(Office)  
 Mr. Friedrichs Corp 176 Front St. N.Y. 678

Window 5'-5" wide by 9' high  
 Divided into 3 panels with 3 figures.

In memory of Georgia Eddy Bone  
 Madison Avenue Methodist Epis. Church  
 Corner Sixtyth Street and Madison Ave  
 New York.

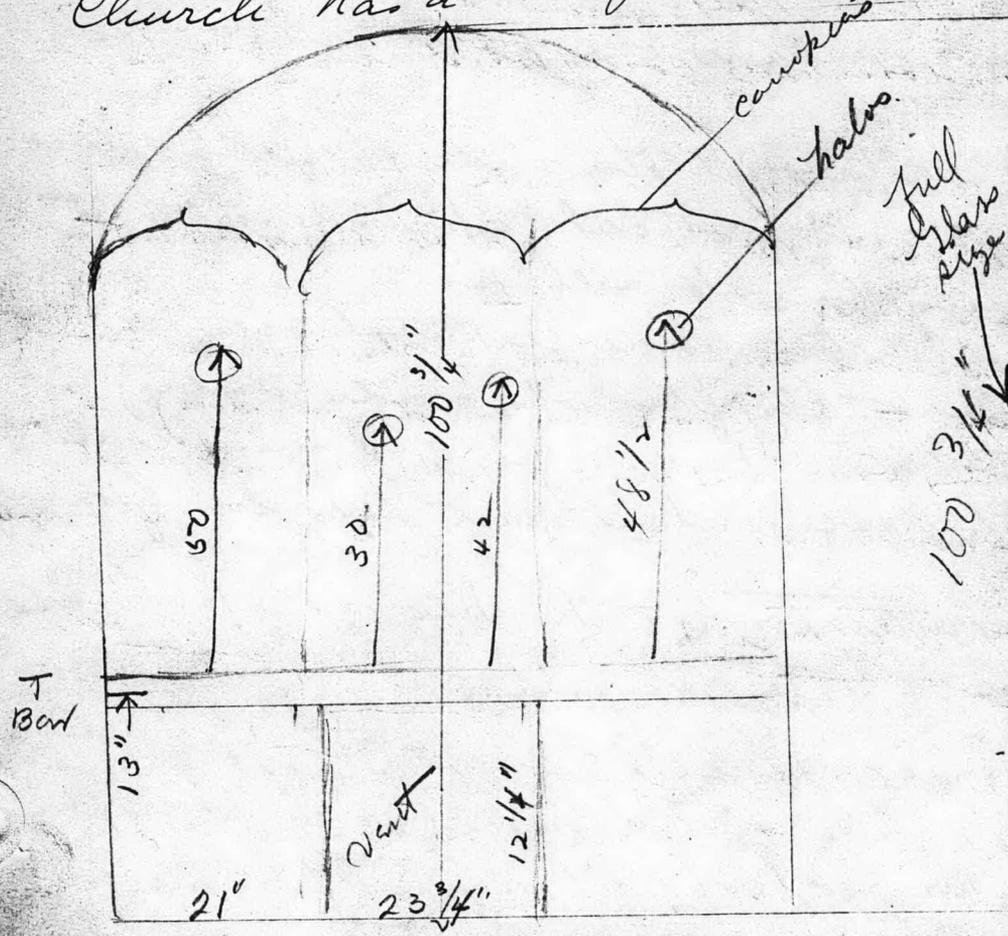
If a frame of  
 the same thickness  
 as that of the next  
 window be substituted  
 for the existing one,  
 which is part of  
 the tracery, the  
 size of your opening  
 from the back of  
 the rebate is  
 $66\frac{3}{4} \times 100\frac{3}{4}$ . The  
 top is a true semi-  
 circle. The rebate  
 is  $\frac{1}{2}$ " deep. The  
 size shown for  
 the ventilator  
 is taken from the  
 centers of the  
 webs of the Truss.

$66\frac{3}{4}$  { ventilator must be }  
 { drop in ventilator }

Mr Houghton writes that the arches of masonry  
opening are not vertical, spreading apart  
from opening line to sill. ~~Mr~~  
man's name who made last desk can be found  
from O.S. Kimberly Co (firm who made windows)  
John H Carl, 510 First Ave) is good man. Could  
copy cash and work to glass etc. we gave you.

Gothic design at the top of the window, and  
particularly the entire panel I do not like at all  
I very much prefer original design  
Appearance of spurs in the cartoons look  
like spindles and needles, while same  
effect in the original design is shorter  
and much more handsome

The feet of the centre figure looks like  
feet of a claw foot table, while originally  
she wore sandals

Original Design The angels were in profile  
Do not like angels with two wings

Also wire screen installed  
Present frame to be removed and replaced  
by single wooden frame of similar  
type and dimensions to those now in place  
Frame of wrought iron T Bars shall be made  
to conform to drawings in the design.
